# WRONG-WAY DRIVER DETECTION & NOTIFICATION SYSTEMS

## **REQUEST FOR PROPOSALS**

## Addendum No. 3

Issued February 26, 2024

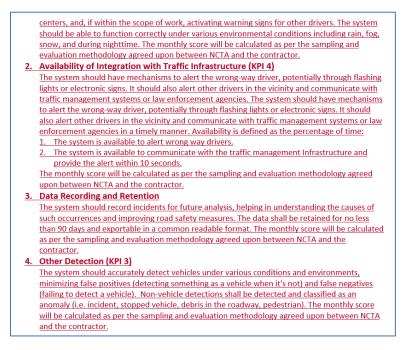
Project Principal:	Installation/Maintenance Manager:
All Scenarios	All Scenarios
Contractor Project Manager:	Quality Assurance Manager:
All Scenarios	All Scenarios
Technical Manager:	Test Manager:
Scenarios A, B, C, D, <del>E</del> , and G	Scenarios A, B, C, D, <del>E</del> , and G
